FINAL DRAINAGE REPORT

FALCON RANCHETTES FILING NO. 2
MERIDIAN STORAGE
El Paso County, Colorado

Add PCD File No.
VR239

Figure 3-2
 Drainage Basin Map
 Falcon DBPS
 El Paso County, CO

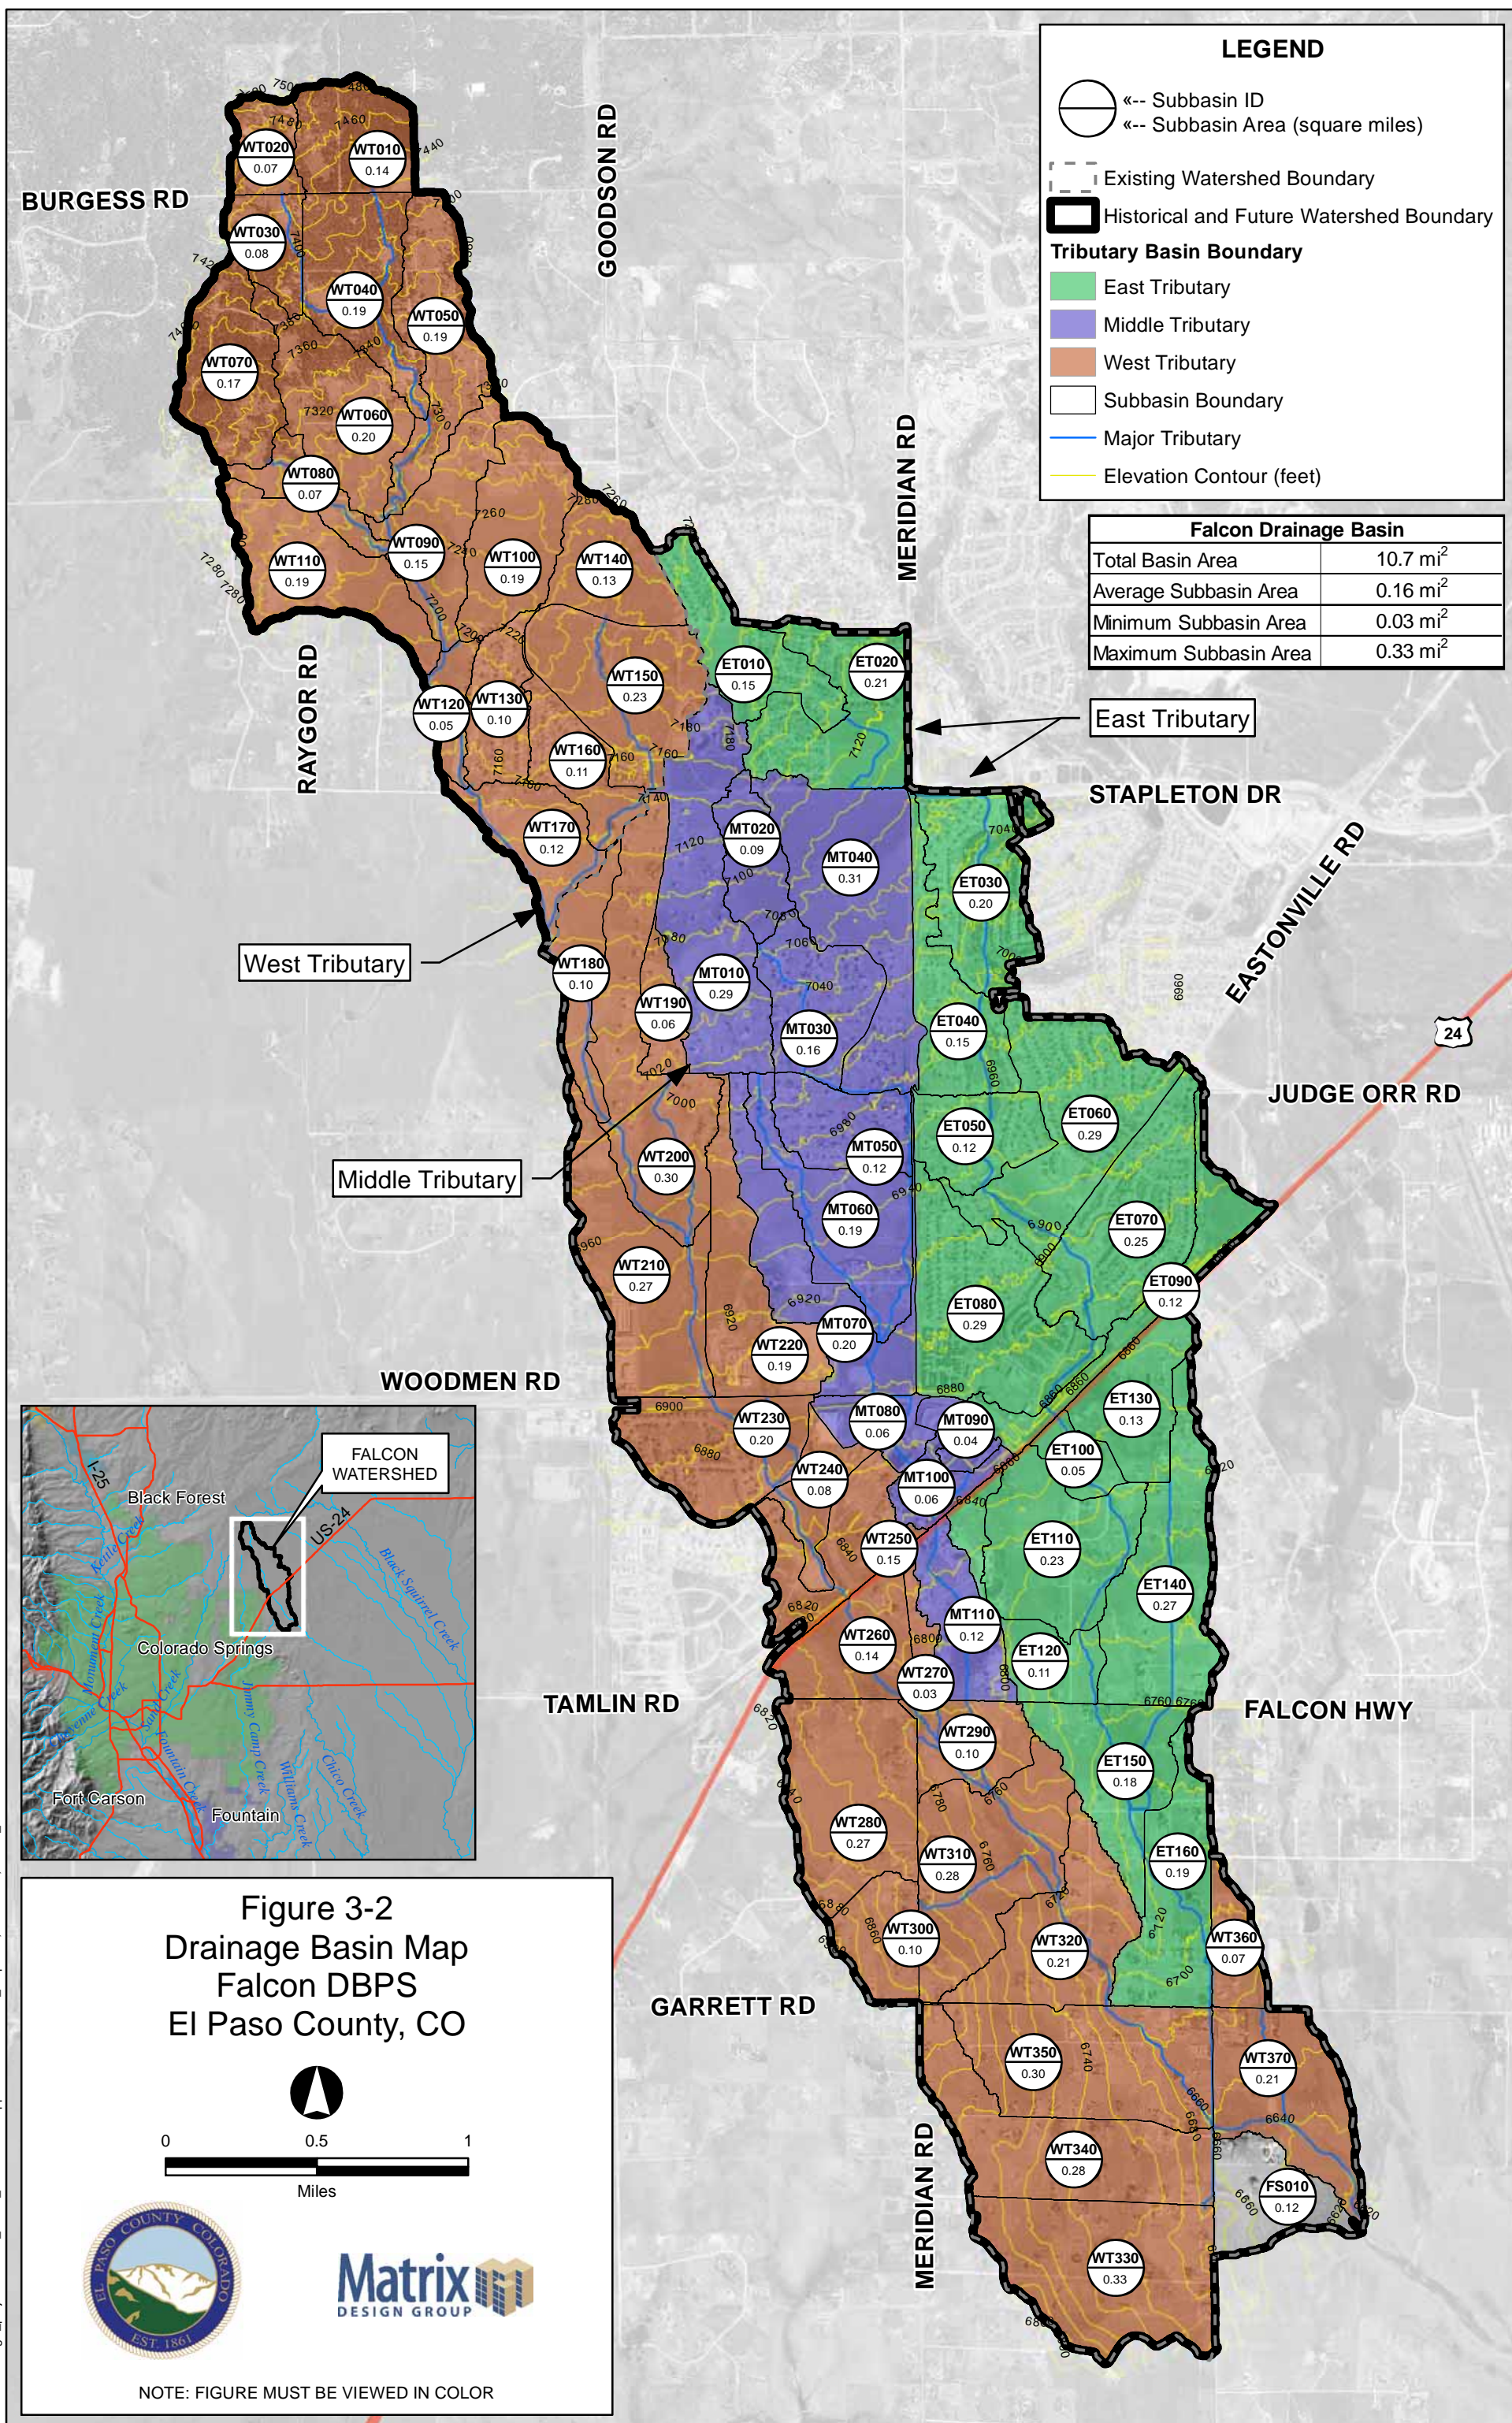
Fix figure - entire background show up as black making the figure difficult to read.

Project: Meridian Storage
 Inlet ID: DP4

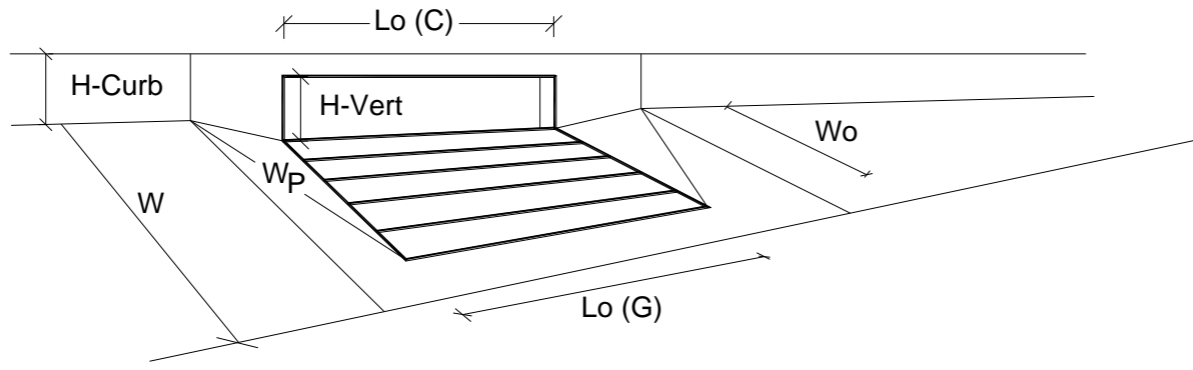
The narrative indicates that Basin B-3 flow is conveyed to this inlet. The flow at basin B-3 is 4.7cfs/8.1cfs (5yr/100yr). Please revise accordingly as it does not appear that the entire flow is being accounted for in this design.

DETENTION BASIN STAGE-STORAGE TABLE BUILDER

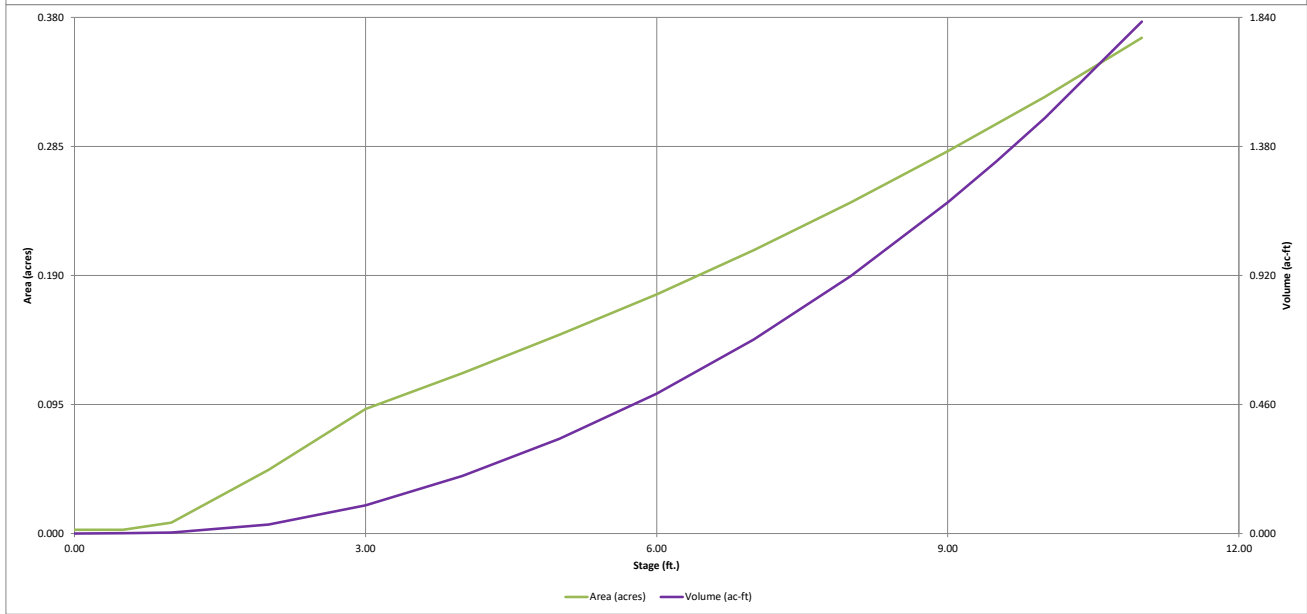
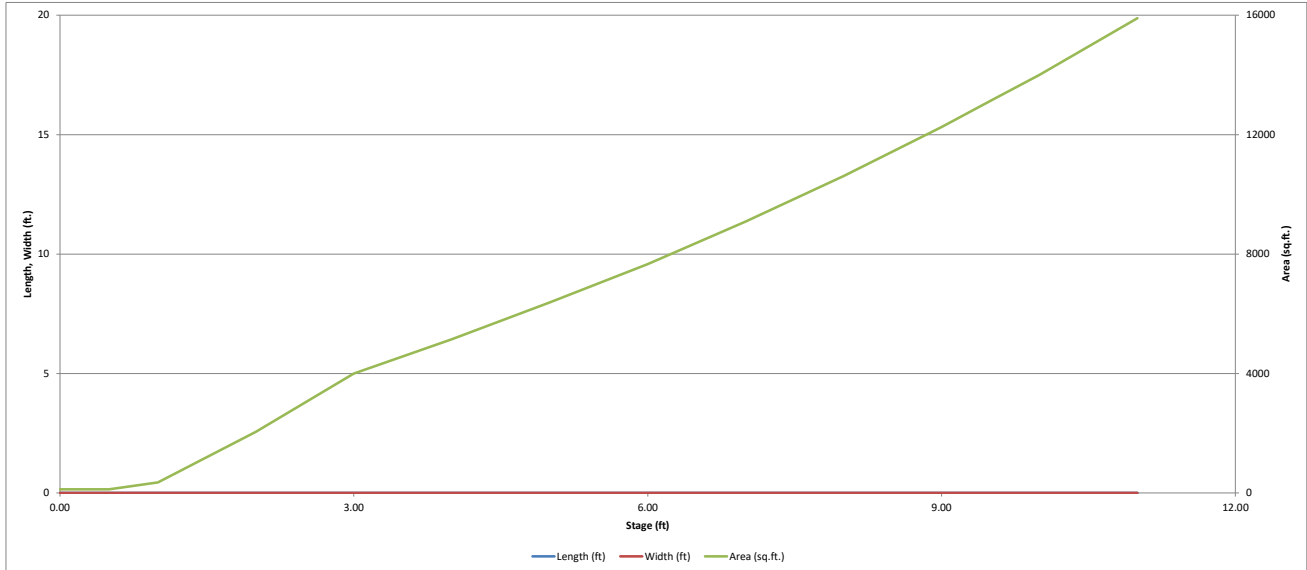
Pond details show 4.79'. Verify and update

3.42 per pond details. Verify and update so both match.

Pond details show 1.75'

Pond details call out 1.16'. Verify and update so both match.

Pond details show 30" RCP

Side slopes are not shown on plans. Update and verify both match.

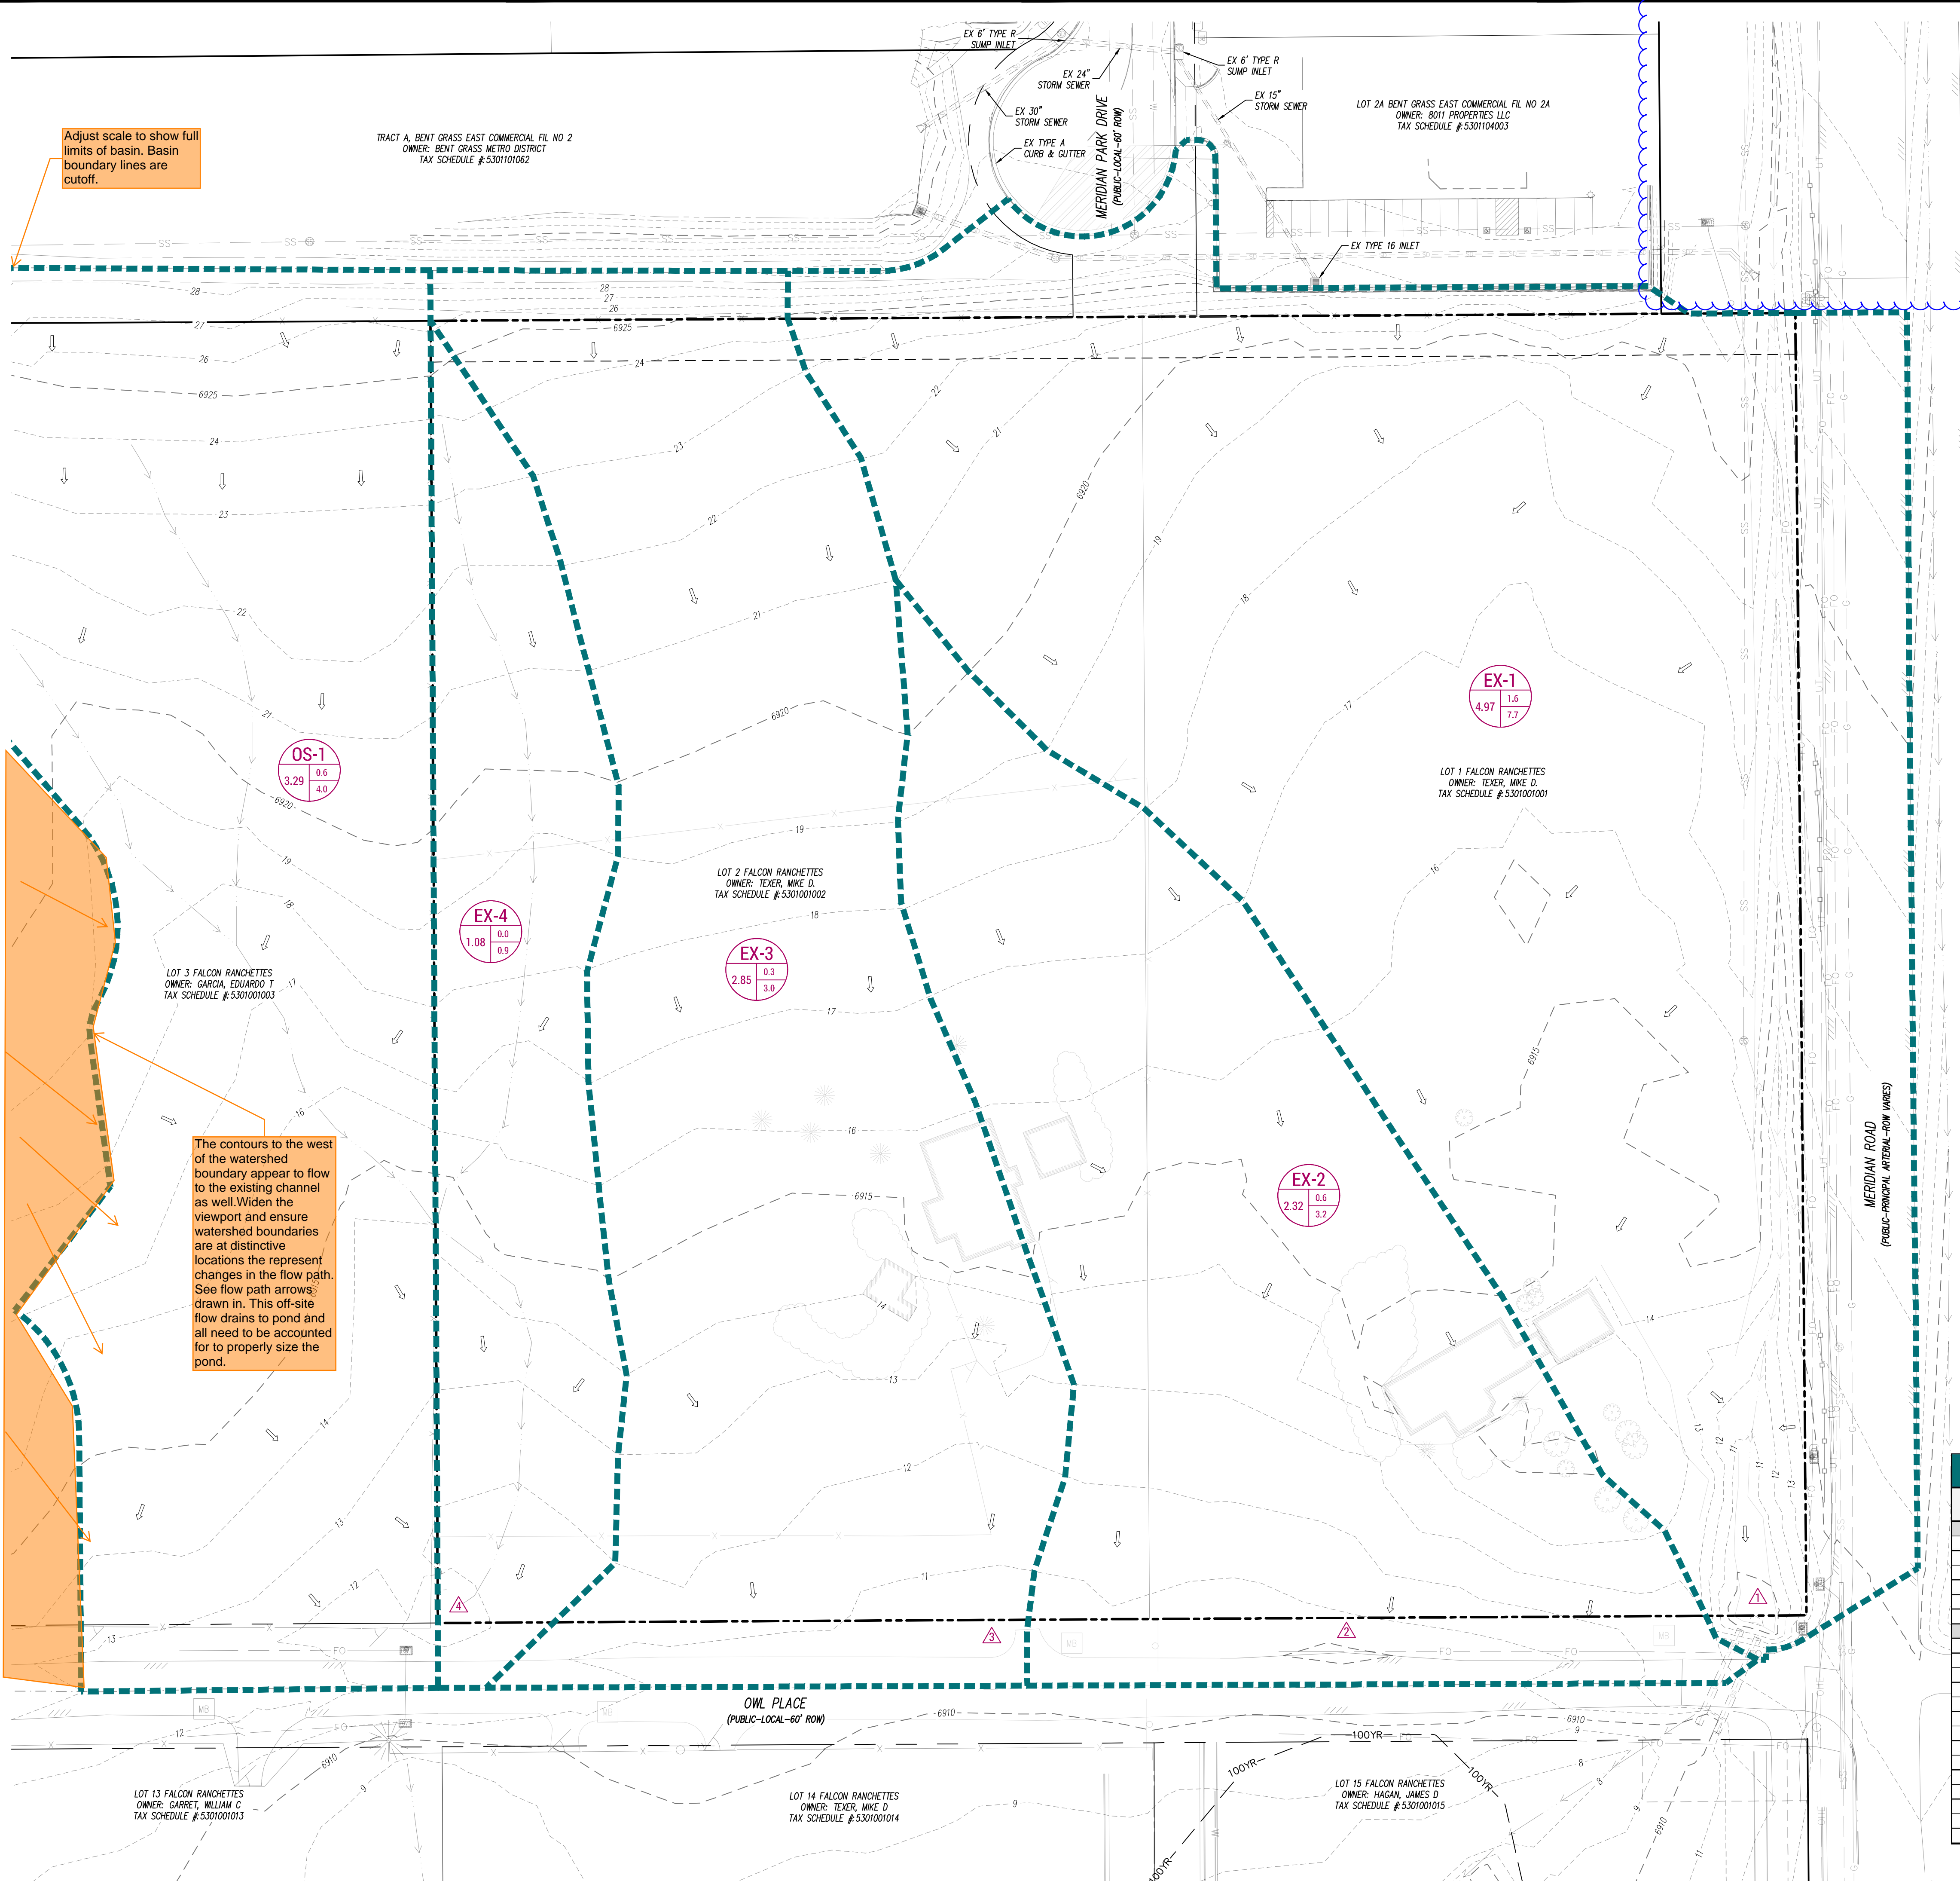
Please account for upstream flow within the channel and from the Bent Grass Commercial pond that is out-falling at this location. Provide the flow entering the site at this location.

Adjust scale to show full limits of basin. Basin boundary lines are cutoff.
